**JOINT REGIONAL PLANNING PANEL
(Sydney West Region)**

JRPP PLANNING REPORT

| JRPP No: | 2011SYW026 |
| Proposed Development: | DEMOLITION OF EXISTING DWELLINGS AND ASSOCIATED STRUCTURES AND CONSTRUCTION OF 5 APARTMENT BUILDINGS 9-11 STOREYS CONTAINING 450 UNITS AND BASEMENT CAR PARKING CONTAINING 662 CAR PARKING SPACES |

Figure 4. Height Variation to Block D (south elevation)

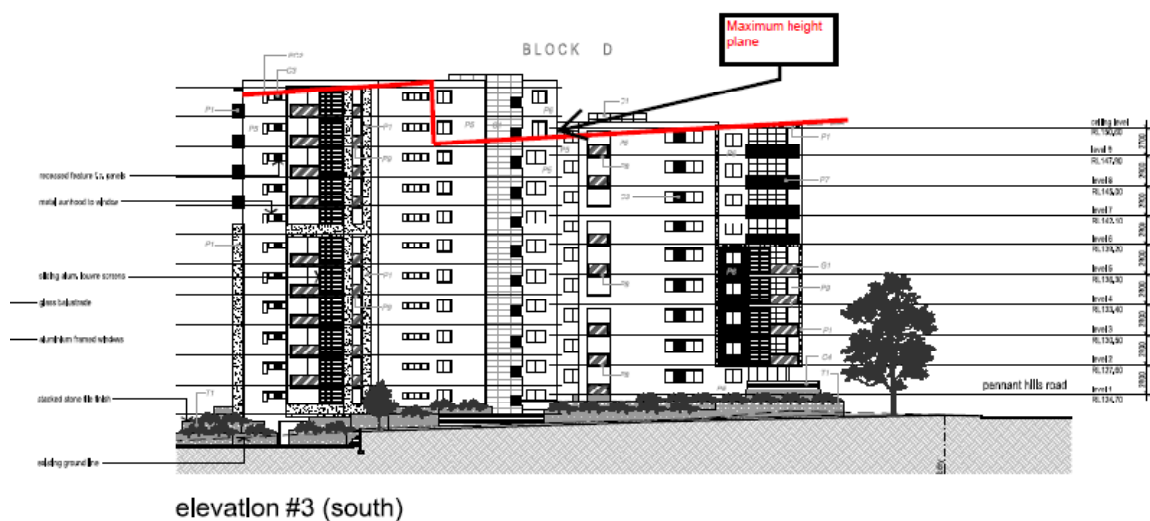
The proposal complies with the FSR standard with an FSR of 2.26:1. In relation to height, the proposal complies with the statutory height requirements with the exception of Blocks D and E. Part of Block E exceeds the 33m height limit by 0.5m and part of Block D exceeds the 27m height limit by a maximum of 6m.

- *It is necessary to provide fill along the southern end of Building E and Building D to ensure that each unit is provided with one level floor plate. In this regard, it is necessary to provide approximately 0.5 metre of fill under both these sections of Building E and Building D. It is this 0.5 metres of fill that results in the southern section of Building E having a height when measured from natural ground level to the upper-most ceiling of 33.5 metres, exceeding the 33 metre development standard. Similarly the same situation exists along the southern elevation of Building D where the 27metre height limit is exceeded by 0.5 metres.*

1. It is considered that the development proposal is consistent with the objectives of the building height development standard.
3. The breach of the 33m height limit by a maximum of 0.5m on the southern elevation for Block E and the breach of the 27m height limit by 0.5m on the southern elevation of Block D is due to the slope of the land across the site. It is proposed to regrade the land to provide a more consistent slope across the site.

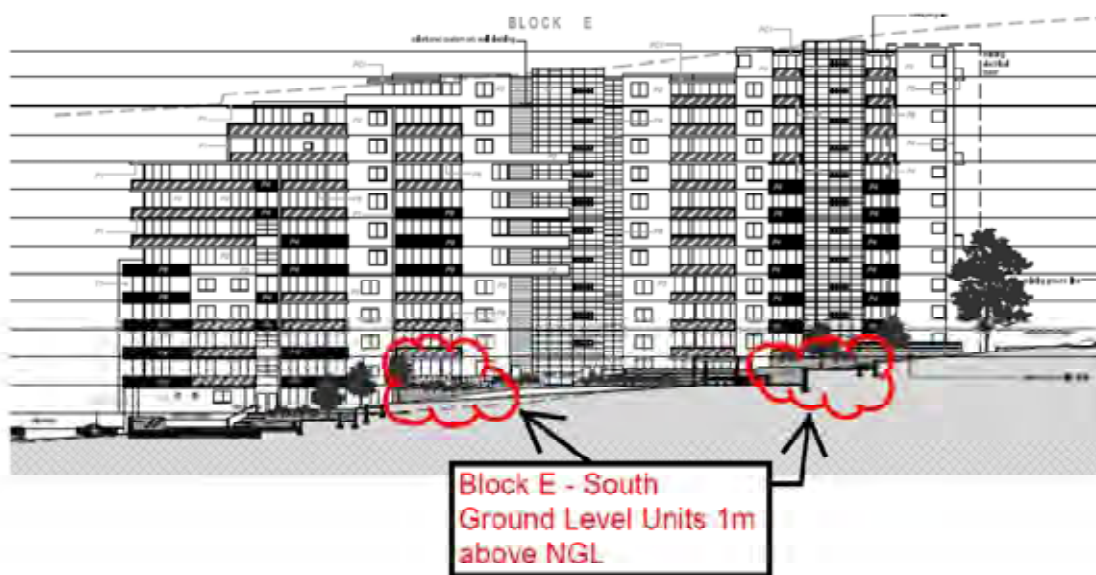
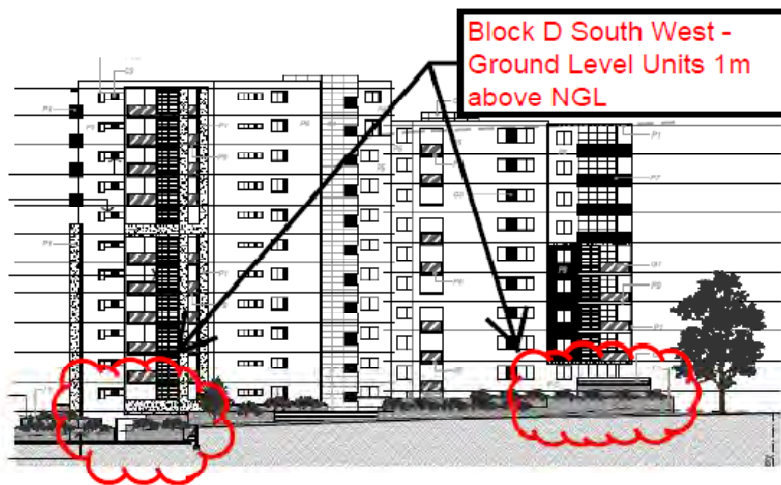
Clause 4.1.2(c) of BHDGP Part E, Section 22 requires developments on sloping sites to be stepped so that the ground floor does not exceed 1m above natural ground level.

The proposal exceeds these requirements at minor sections on the western elevations of Blocks A, B and D and the southern elevation of Block E.

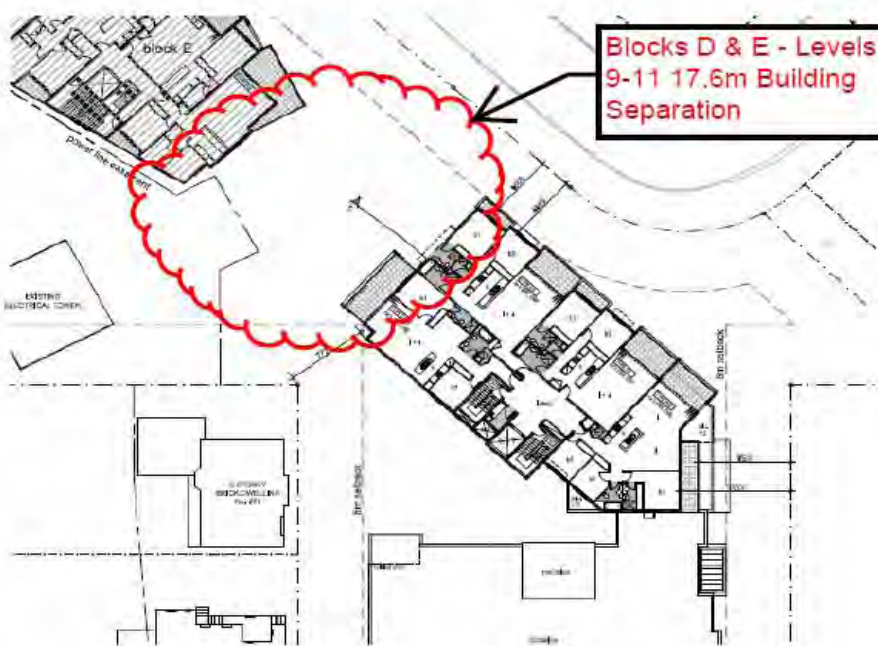
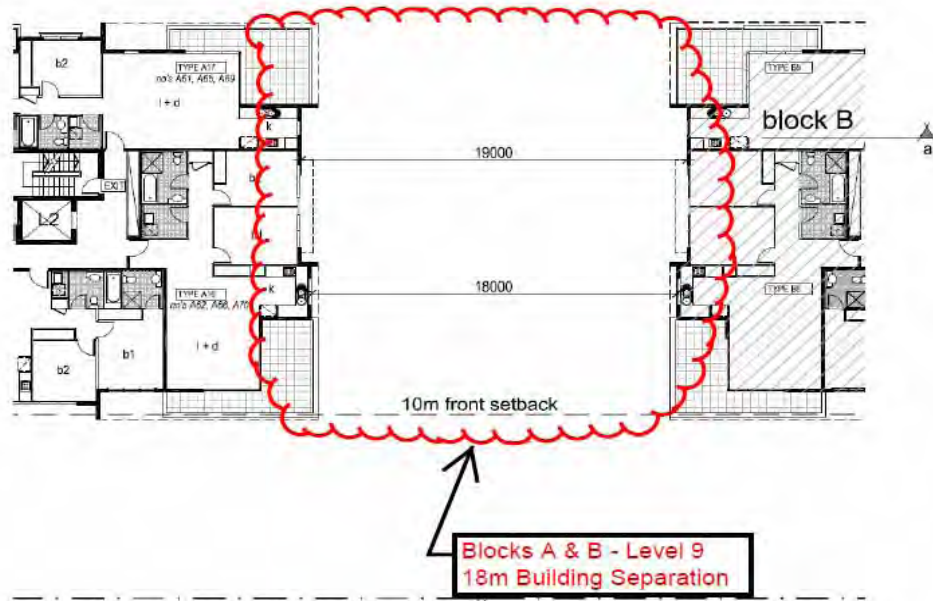
- 4 storey:
 - 12m between habitable rooms/balconies
 - 9m between habitable/balconies and non-habitable rooms
 - 6m between non-habitable
- 5-8 storeys:
 - 18m between habitable rooms/balconies
 - 12m between habitable rooms/balconies and non-habitable rooms
 - 9m between non-habitable rooms
- 9 storeys and above:
 - 24m between habitable rooms/balconies
 - 18m between habitable rooms/balconies and non-habitable rooms
 - 12m between non-habitable rooms

Minimum separation of 17.6m between Blocks D & E being 11 storey buildings and 18m between Blocks A and B is proposed.

The Residential Flat Design Code recognises that building separation controls may be varied in response to site and context constraints. The proposed separation is restricted due to the irregular shape of the development site and the proposed public open space cutting across the development site.

The internal design of individual units between Blocks D and E and Blocks A and B satisfactorily address any concerns relating to privacy. The proposed buildings provide articulated facades set back from the front, side and rear boundaries with variable distances to generate modulated buildings with fragmented facades and alternating colours and materials. The orientation of the buildings is such that the primary sight lines from the relevant units are towards the road frontages or public open space areas.

ATTACHMENT 7 – SIGHT LINE DIAGRAM TO NOS. 2-6 SHIRLEY ST

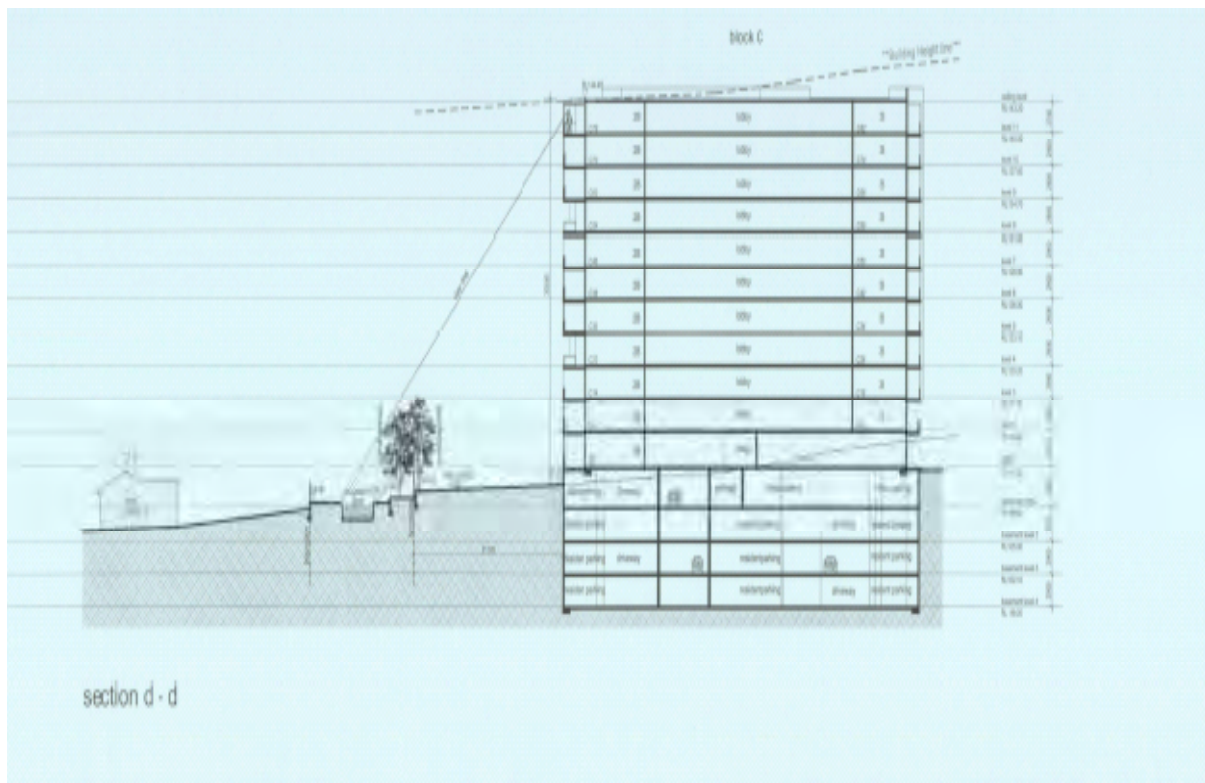
Comment: The applicant has submitted the requested sight line diagrams which demonstrate that potential privacy impacts to Nos. 2-6 Shirley Street has been satisfactorily addressed in particular from upper levels.

Comment: It is recommended that a condition be imposed in any consent to require that the lowest 4 balcony levels contain obscure/opaque screening to limit the potential for direct overlooking of the property at Nos. 2-6 Shirley Street. Refer to Condition No. 4.
